ADDENDUM NO. 1

**Administration Building Renovation Re-bid
Compton Community College District**

tBP Project. No. 20987.00

tBP/ARCHITECTURE

drawing title:
REFLECTED CEILING
PLAN - DEMOLITION

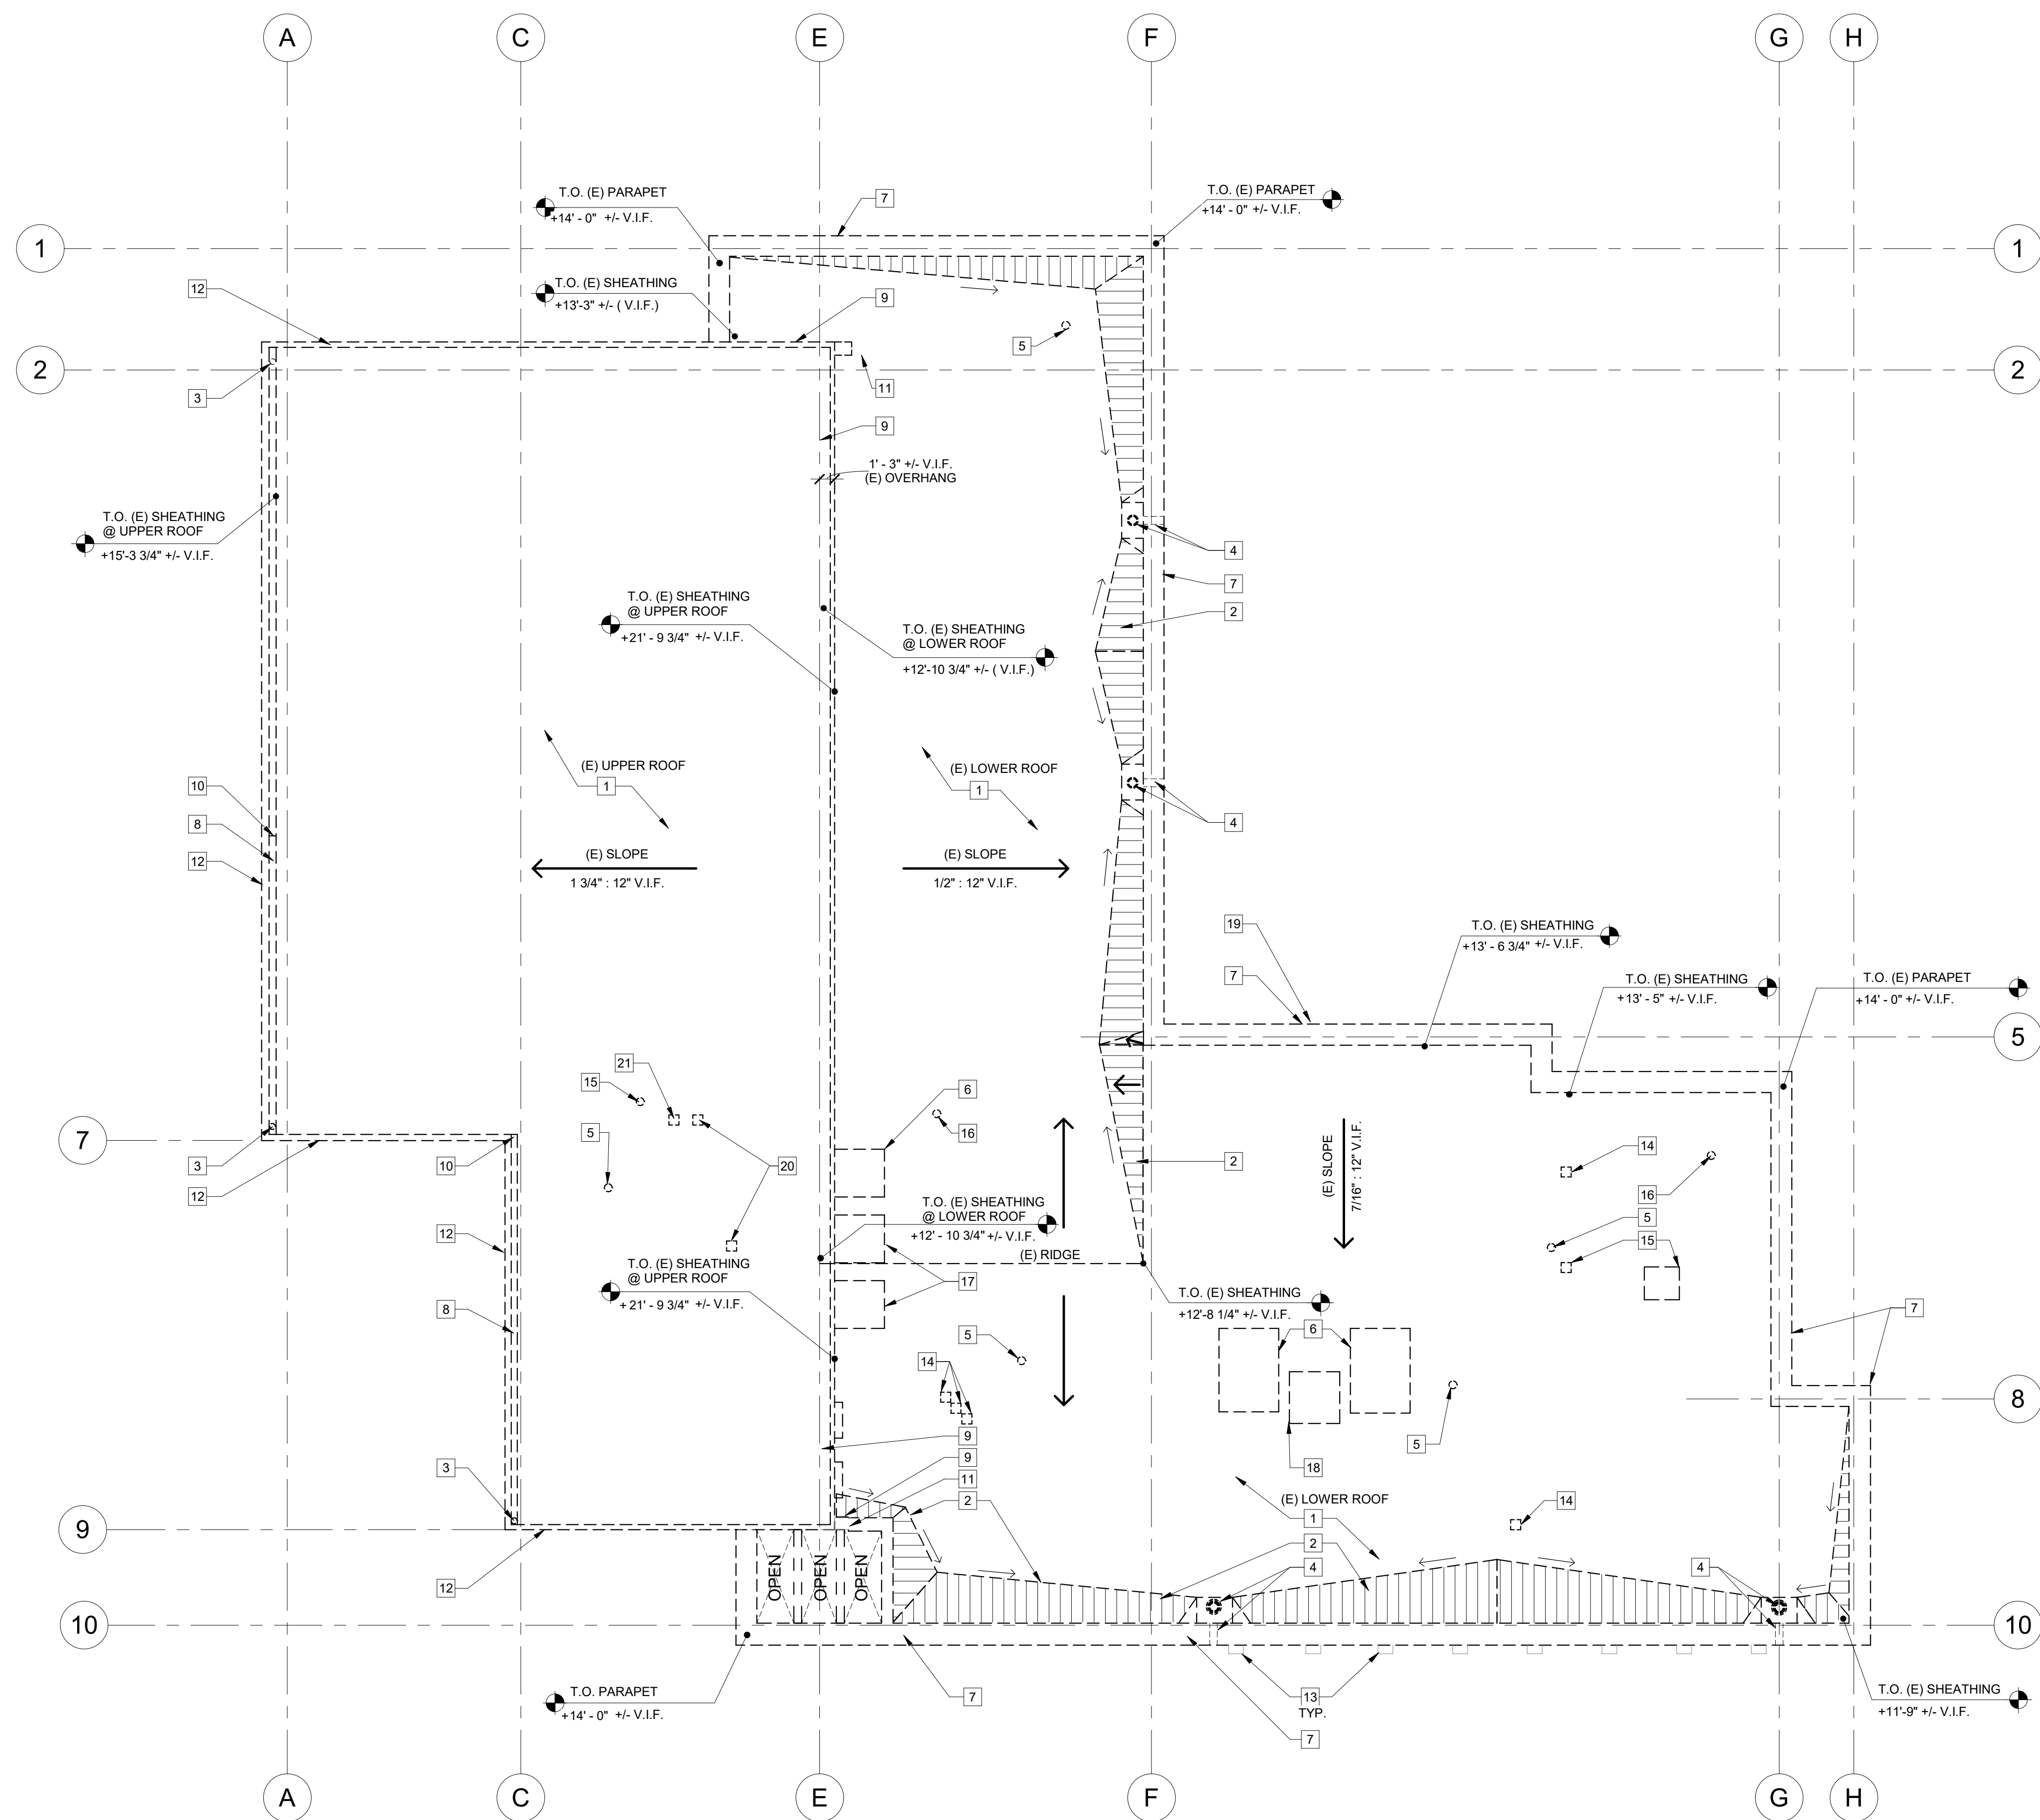
3. **Revised SHEET A0-2 REFLECTED CEILING PLAN DEMOLITION**

- a. Corrected general notes to clarify ambiguous scope notes.
- b. Added ceiling demo scope where walls are removed in Restrooms.
- c. Added the demolition of the original building phone booths.
- d. Identified and noted area of new access panels for fire alarm upgrade to President's office area.
- e. Clarified ceiling to be removed at Women's Lounge room.
- f. Reworded demo notes 1, 5 and 7.
See attached revised Full size sheet identifying revisions included as part of this addendum.

drawing title:
ROOF PLAN - DEMOLITION
drawing no.:
A0-3
drawing of

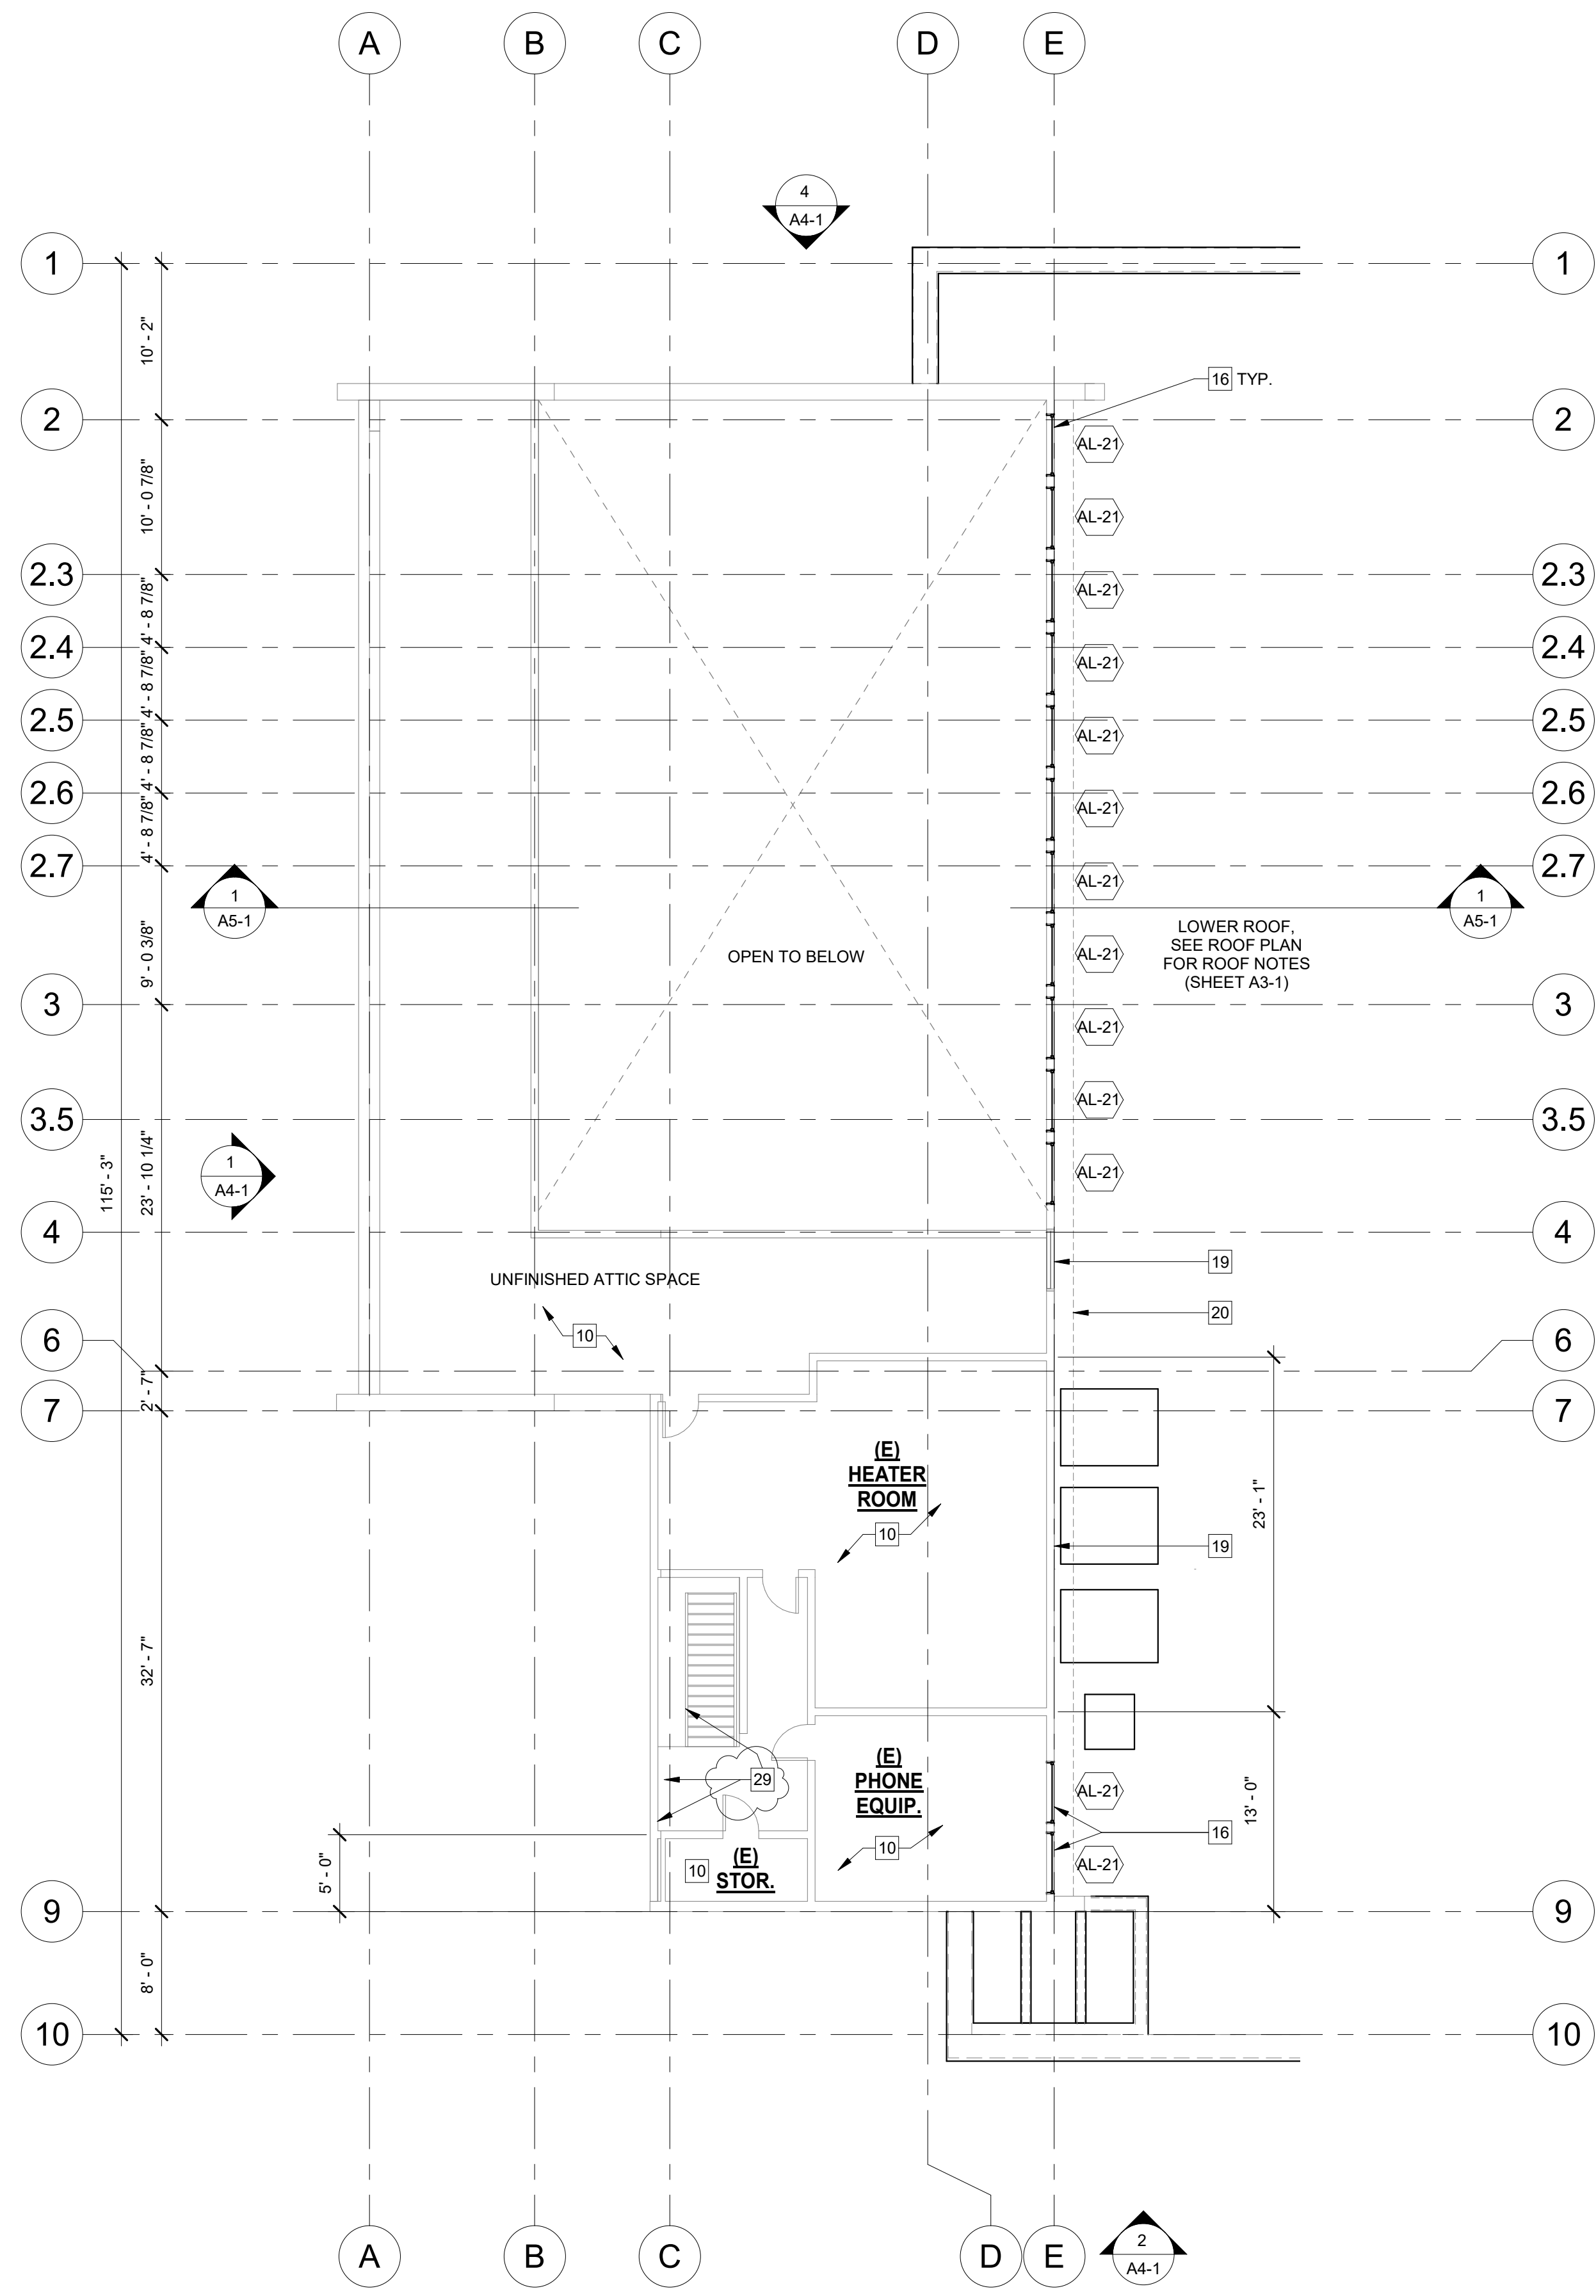
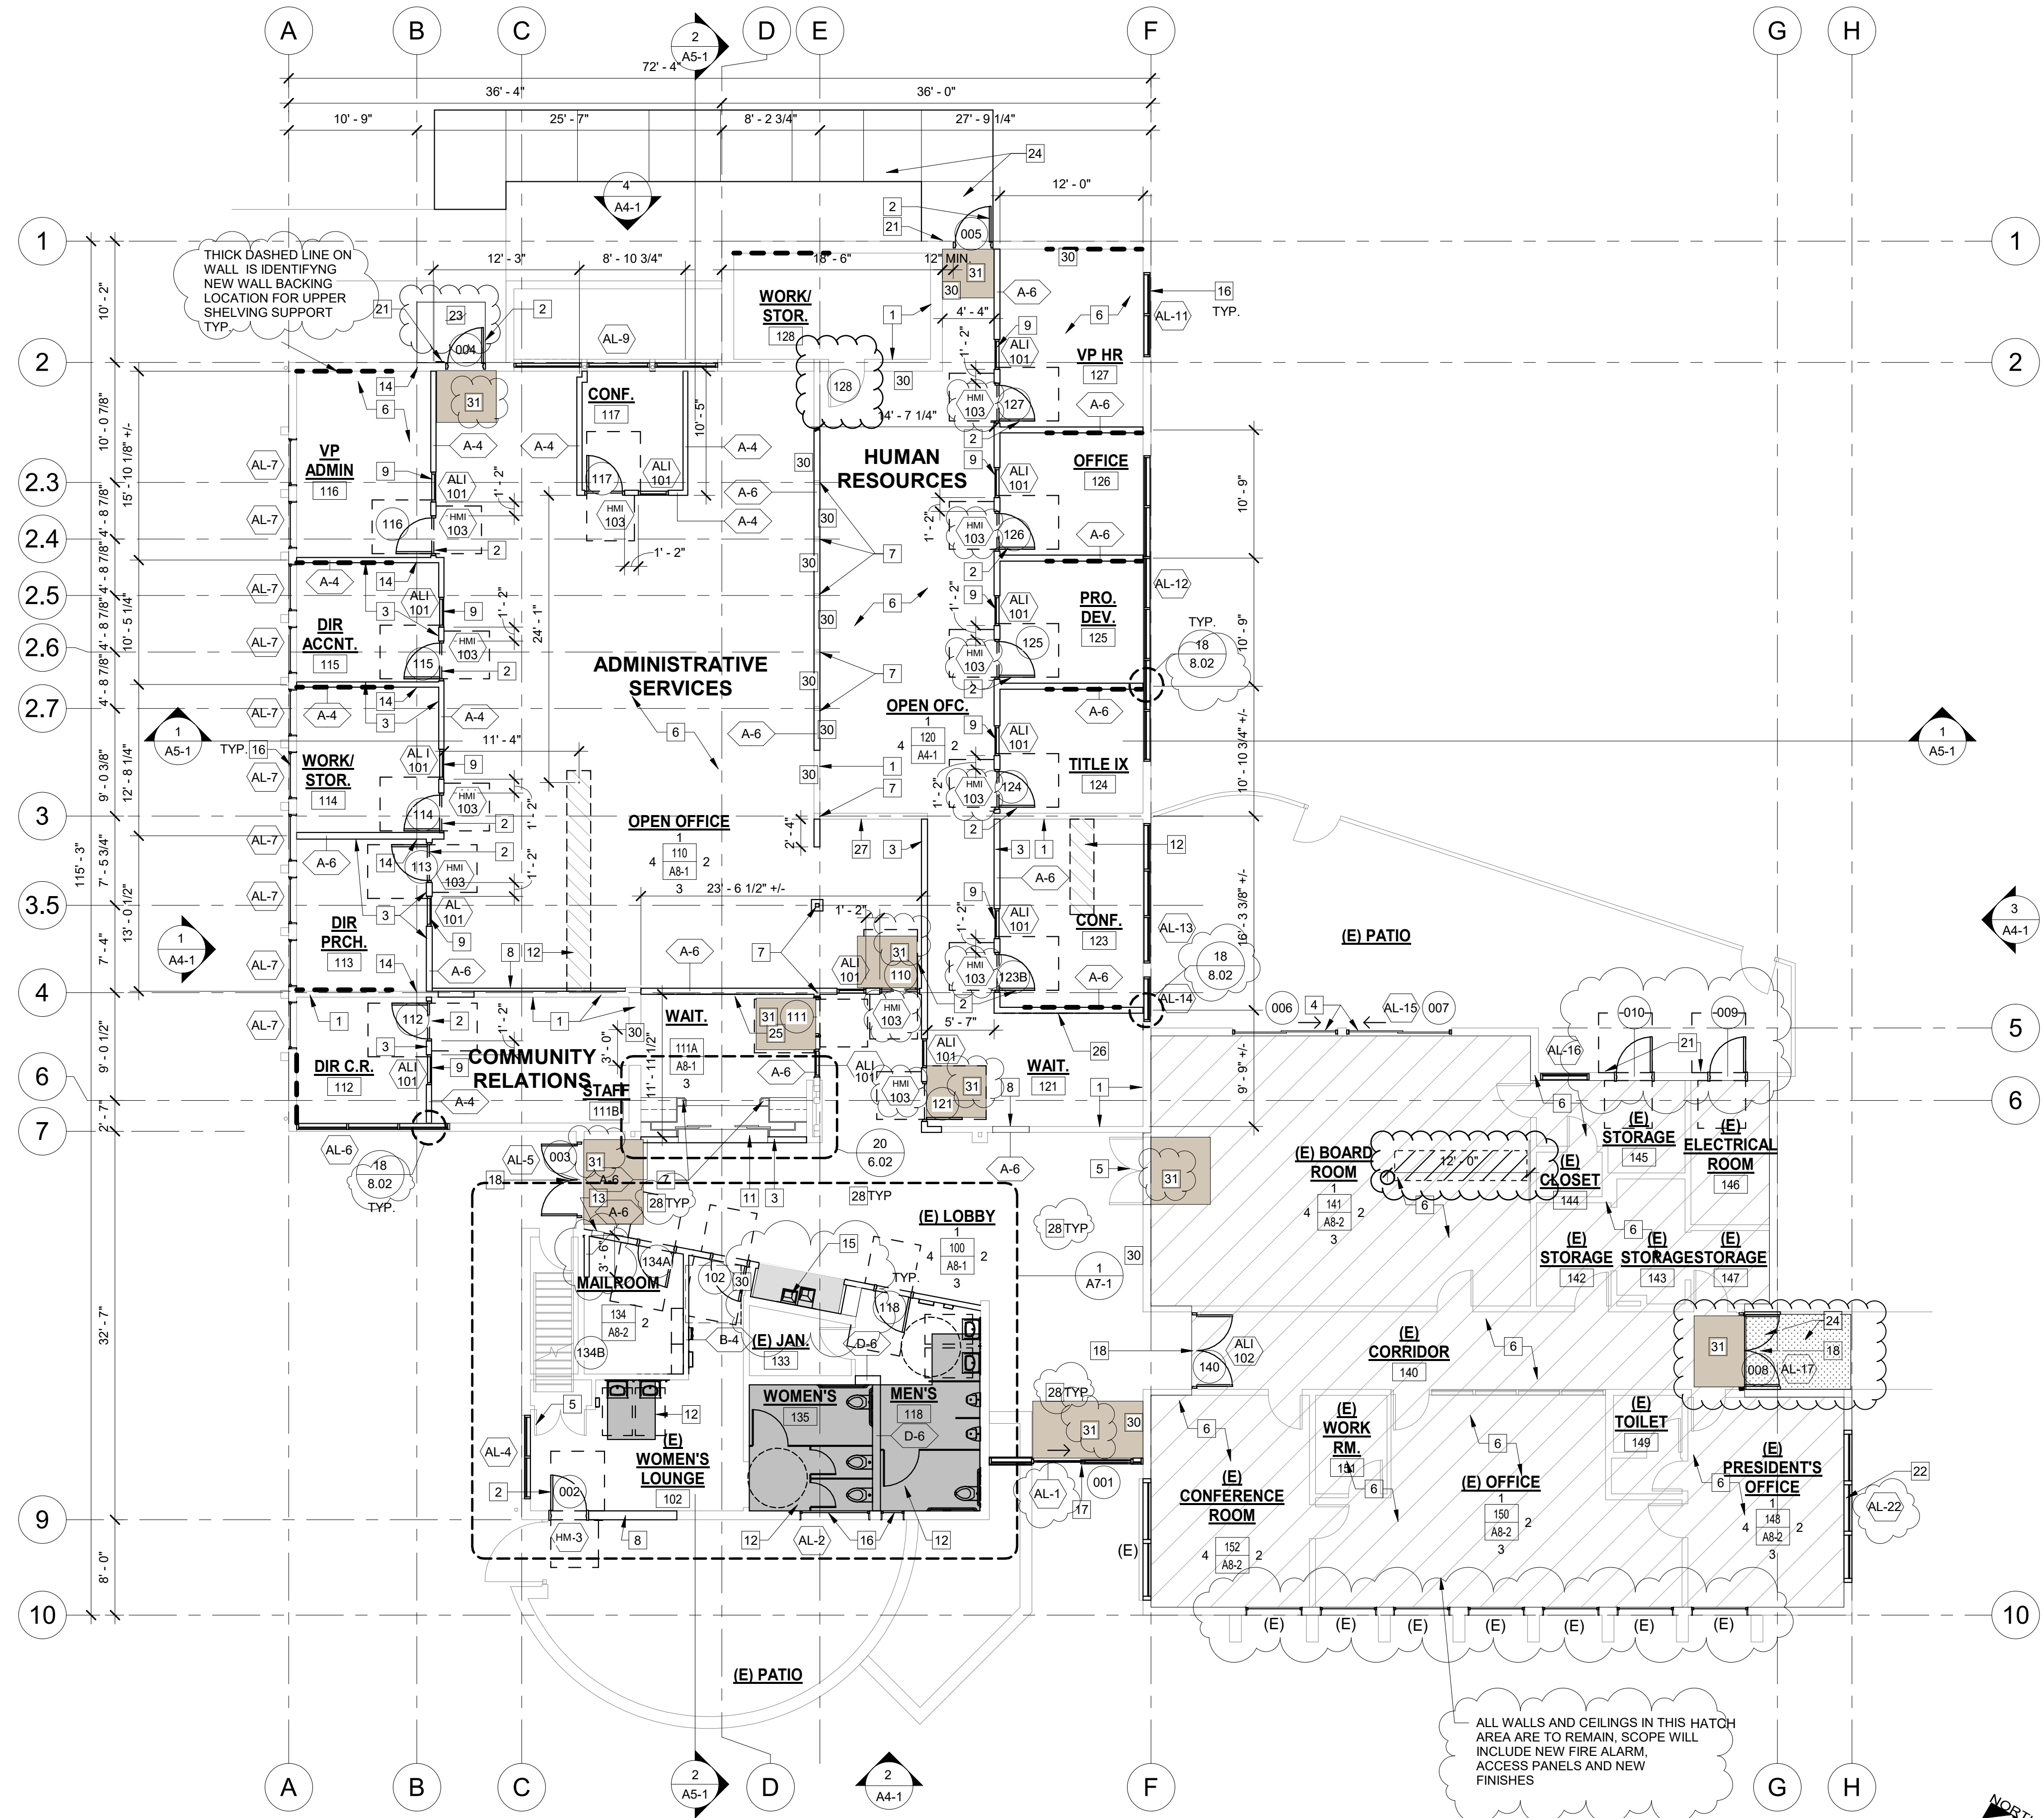
4. **Revised SHEET A0-3 ROOF PLAN DEMOLITION**

- a. Corrected general notes and key notes to clarify ambiguous scope notes.
- b. Reworded general notes and demolition key notes 4,6,7,8 & 18.
See attached revised Full size sheet identifying revisions included as part of this addendum.
